Pennsylvania
**Department of
Environmental Protection**

Re: DEP FILE E0205225-004
Technical Deficiency Letter
New High School Campus
Leet Township, Leetsdale & Edgeworth Boroughs
Allegheny County

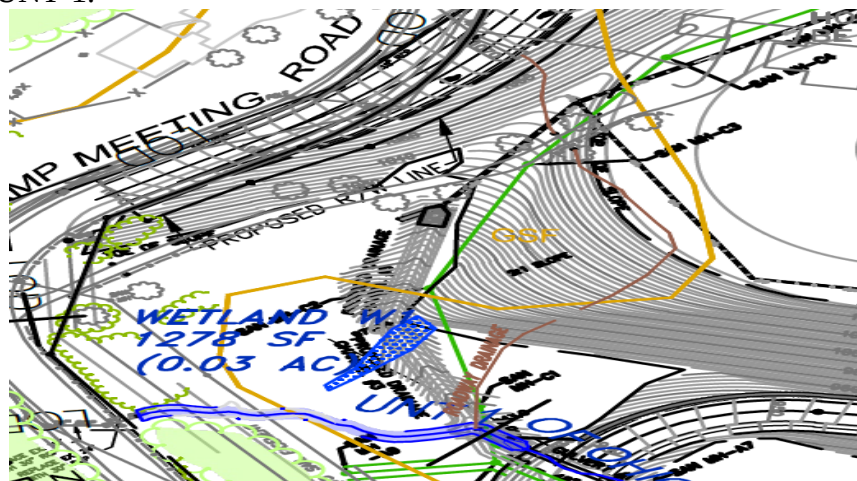
6. §105.261(3): There is a proposed wall and associated grading to support the pedestrian walkway along UNT 2 on the south end of the project. Based on the existing contours, it does not appear that

the stream would be confined to the channel delineated on the drawings. Please provide additional documentation which demonstrates that the stream channel is confined to what is shown on the plans at this location. It may be helpful to provide cross sections for this part of the stream which also shows the proposed wall and grading. If it cannot be demonstrated that the stream here is confined to the channel during the 100-yr storm flows, this wall and the proposed grading would be considered an aquatic resource impact. Additionally, because the wall and proposed grading would be constricting the channel, an H&H analysis will need to be done to evaluate the flood heights and flow velocities in this section.
